Access Compliance Report Public Rights-of-Way (Pedestrian Signals)

Main Street: 17TH_ST Cross Street: ESPLANADE_AVE Location: NW

ADA ID: SGRK211007121507 Signal Type: One Push Button-APS Overall Compliance: No Severity Scores: BTN 1: 25 BTN 2: N/A No BTN: N/A

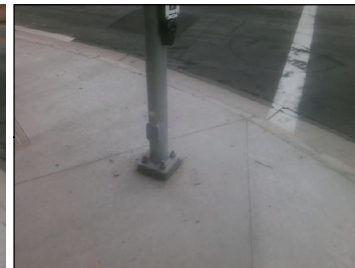
OC Std/PROW: R404.2

Possible Solutions: Remove and Replace Clear Space.
